YWW 50/60 TU Sill and Sill Flashing Revision

Feb 14, 2025

YKK AP is excited to announce improvements to the sill flashing assembly for the **YWW 50 TU** and **YWW 60 TU** window wall systems. Based on customer feedback, these updates were made to enhance system performance, frame assembly, and maximizing room for anchor bolts using methods similar to YWW 60 XT.

Enhanced Sill Design:

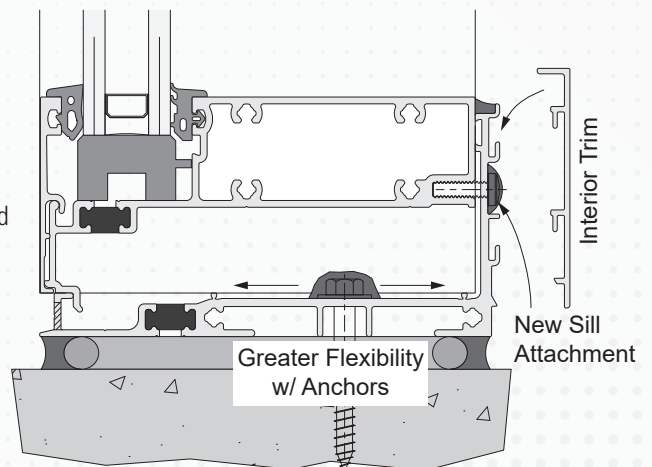
- New attachment method occurs at the interior to optimize field installation and performance.
- Revised design allows for better anchorage tolerances, particularly with embed anchors.
- New sill design allows for an integral mullion to be incorporated within glazing units.

- Interior trim conceals sealant and fasteners and is available in two depths to meet specific conditions.
- Interior sill covers can be installed after interior construction, offering added protection against physical damage.
